Access Compliance Report

Public Rights-of-Way

Intersection ID: 48557	Main Street: RIDGEFOREST_DR	Cross Street: ARDREY_WOODS_DR	Location: NW
ADA ID: D6A12A52ABBC	Ramp Type: PerpDiag	Initial Pass/Fail: Fail	Overall Compliance: No
		Severity Score: 30

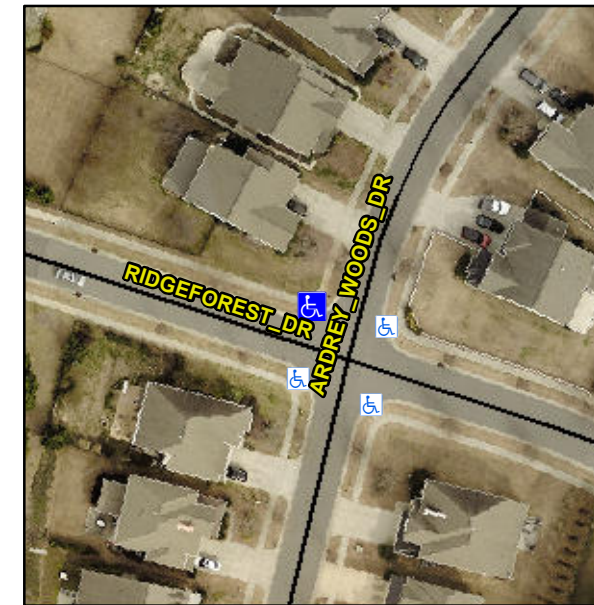
Not Found, R304.5.1, R304.5.3

Compliance	Description	Data	Compliance	Description	Data
N/A	Ramp Length (in)	72.0	Yes	Ramp Slope (%)	7.2
No	Ramp Width (in)	32.0	No	Ramp XSlope (%)	6.3
N/A	Flare Type LT	N/A	N/A	Flare Type RT	N/A
N/A	Flare Slope LT (%)	N/A	N/A	Flare Slope RT (%)	N/A
N/A	Flare Traversable LT?	N/A	N/A	Flare Traversable RT?	N/A
N/A	Landing Length (in)	N/A	N/A	DWS Provided?	N/A
N/A	Landing Width (in)	N/A	N/A	DWS Contrast?	N/A
N/A	Landing Slope (%)	N/A	N/A	DWS Length (in)	N/A
N/A	Landing X Slope (%)	N/A	N/A	DWS Full Width?	N/A
N/A	Landing Curb? (Y/N)	N/A	N/A	DWS Offset (in)	N/A
N/A	Shared Landing?	N/A			
N/A	Gutter Ponding?	N/A	N/A	Gutter Slope (%)	N/A
N/A	Gutter Lip Ht (in)	N/A	N/A	Gutter X Slope (%)	N/A
N/A	Painted X Walk1?	No	N/A	Painted X Walk2?	No
	X Walk 1 Direction	To SW		X Walk 2 Direction	To SE
N/A	X Walk 1 Width (in)	N/A	N/A	X Walk 2 Width (in)	N/A
	X Walk 1 Slope (%)	2.2		X Walk 2 Slope (%)	2.1
	X Walk 1 X Slope (%)	4.2		X Walk 2 X Slope (%)	0.8

Remove & Replace Curb Ramp With Two New Directional Ramps or Equivalent.
